STATE OF VERMONT AGENCY OF TRANSPORTATION

PROPOSED IMPROVEMENT SAFETY PROJECT TOWN OF SPRINGFIELD COUNTY OF WINDSOR

PROJECT DESCRIPTION: PARTICIPATION: REPAIR AND REHABILITATION OF EXISTING METAL BINWALL ALONG LEFT SIDE OF TH 1, INSTALLATION OF NEW DRAINAGE AND SIDEWALK ALONG LEFT SIDE OF TH 325, COLD PLANING AND PLACING NEW BITUMINOUS CONC. PAVEMENT ON TH 325 .

RECORD PLANS

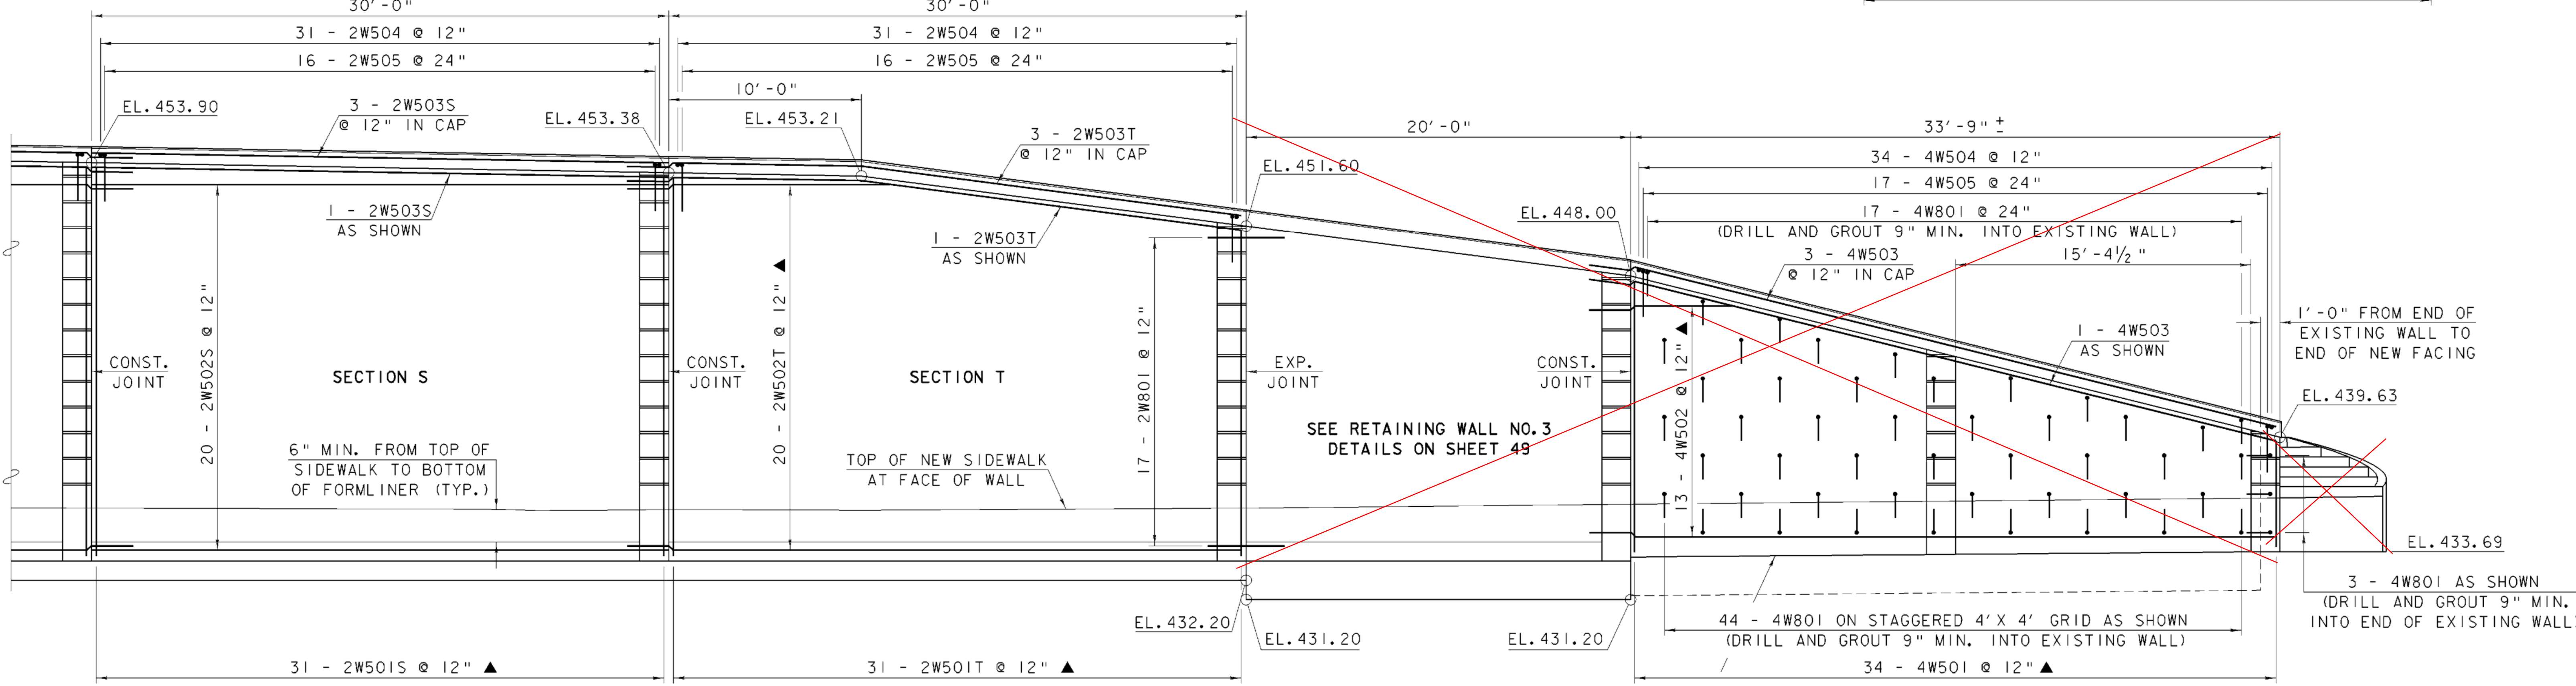
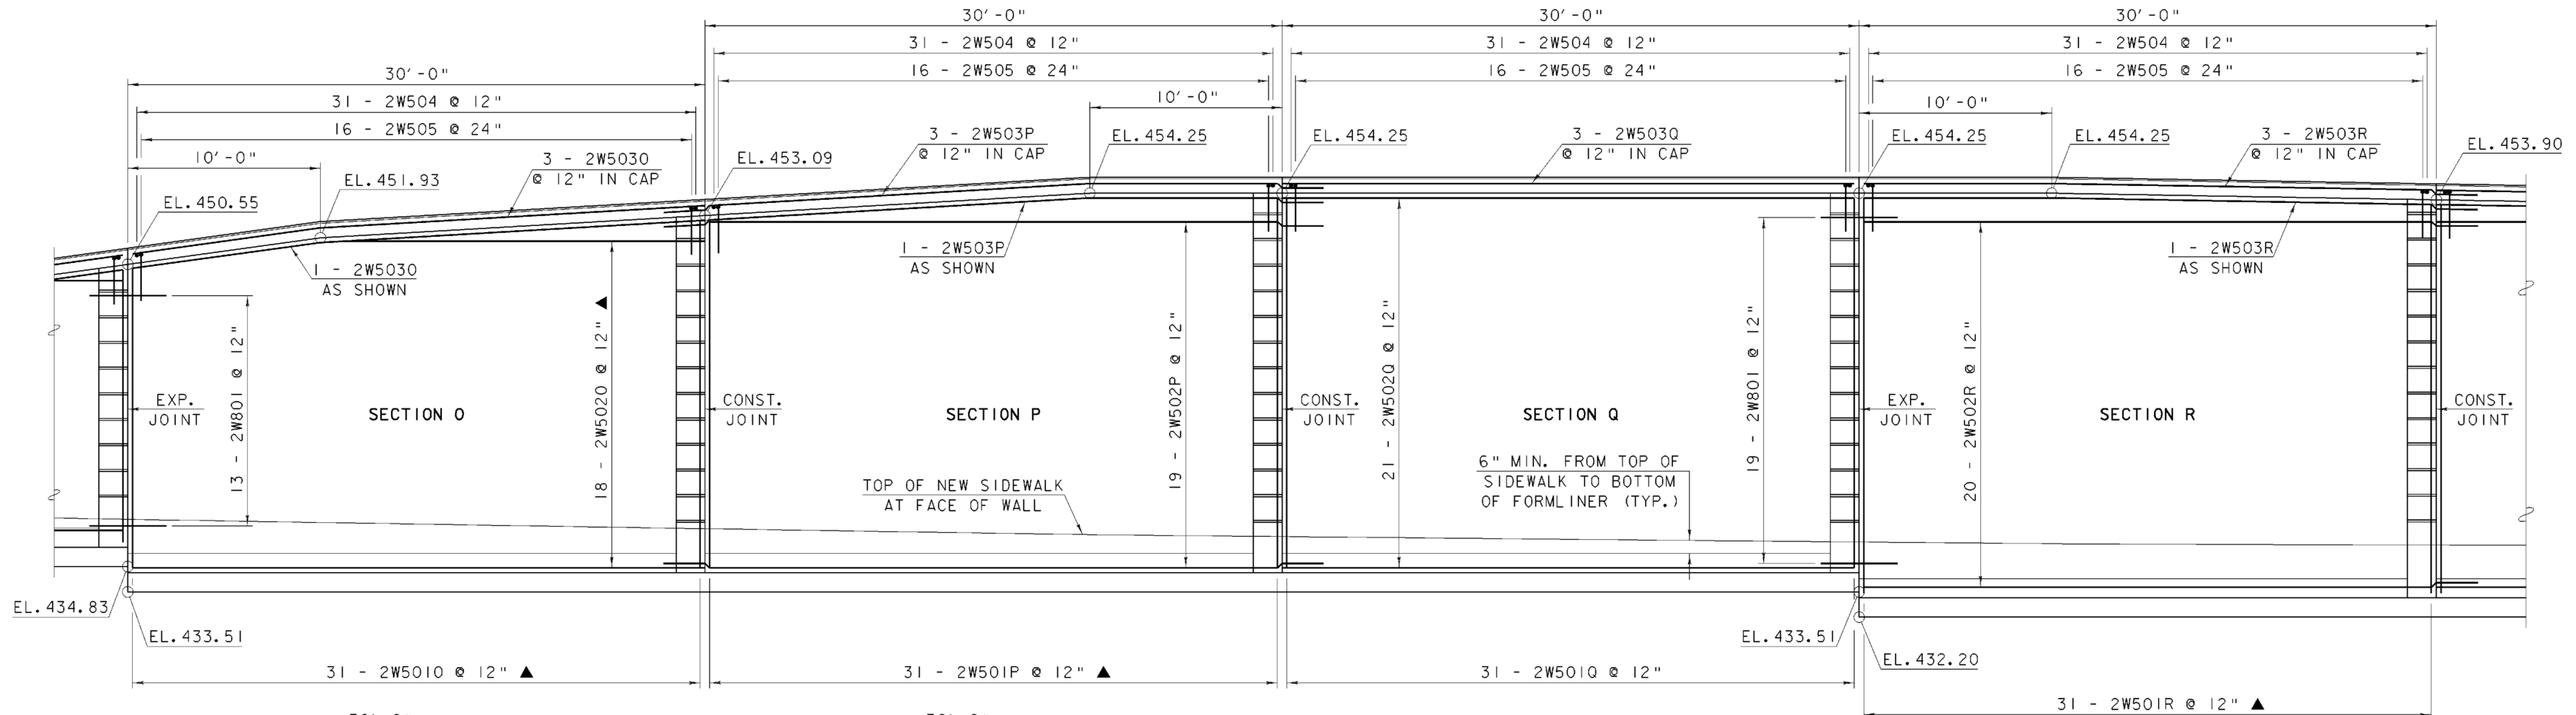
EXTEND FACING TO TOP OF EXISTING FOOTING

SEE REVISED ELEVATIONS IN VALUE ENGINEERING PLAN SET.
